TO: Oregon Transportation Commission
FROM: Siskiyou Velo (the largest bike club in Southern Oregon w/ over 250 members)
DATE: February 17, 2016
RE: Draft Oregon Bicycle and Pedestrian Plan

TECHNICAL REPORT

DRAFT – OREGON BICYCLE AND PEDESTRIAN PLAN

Figure 1 - ORS 811.065

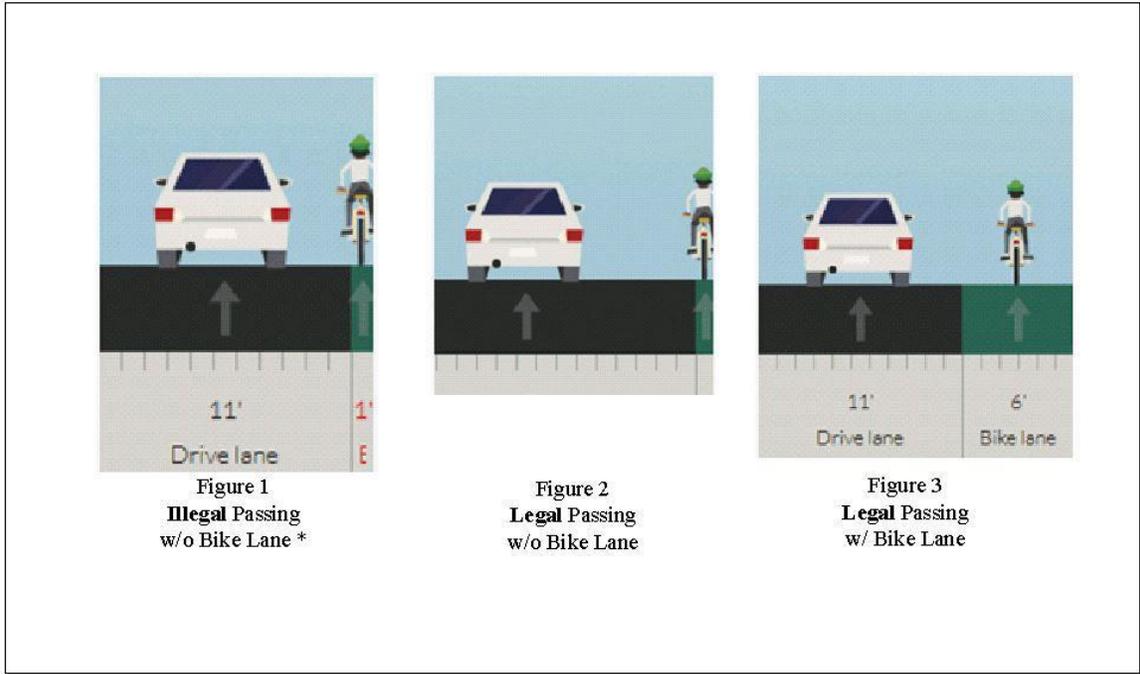
ORS 811.065 requires safe passing of people riding bicycles but auto drivers typically ignore the law and infringe on the road space occupied by cyclists (see Figure 1). The outcome can partially be attributable to cyclists who do not operate his/her bike as a vehicle by riding on a too narrow road shoulder along a roadway with lanes too narrow to effectively share (lanes less than 14 feet). To legally pass a bicycle under these circumstances a motorist must pass with “sufficient (separation) to prevent contact with the person operating the bicycle if the person were to fall into the driver’s lane of traffic.” A legal passing maneuver is shown in Figure 2 and is striking similar to the separation distances when a bicyclist in a bike lane is passed (see Figure 3).

Despite ORS 811.065 being the law in the State for almost a decade, motorist and cyclists alike are unfamiliar with its requirements. More disturbing is that ODOT has done little or nothing to address widespread ignorance of the law. Figure 1, below, shows how easily the requirements of the law can be graphically illustrated.

The Club has shared this illustration with ODOT officials who rejected the suggestion that it be used as a road side sign (justifying its rejection based upon its exclusion from the Manual of Uniform Traffic Control Devices (MUTCD)).

The OBPP policies/strategies should explicitly require that “change lanes to pass bicycles” signs be erected on ODOT and local governments roads, streets, and highways where posted speeds are above 35 MPH, bike lanes are not present, the centerline is marked, and travel lanes are less than 14 feet in width. It is critical that signs be placed on urban streets and highways (especially along commuter routes), as well as on rural roads and highway where bicyclist can be expected (such as but not limited to State scenic bikeways, routes leading to Crater Lake National Park, Cascade Lakes Scenic Byway, Coast Highway, US 197, etc).
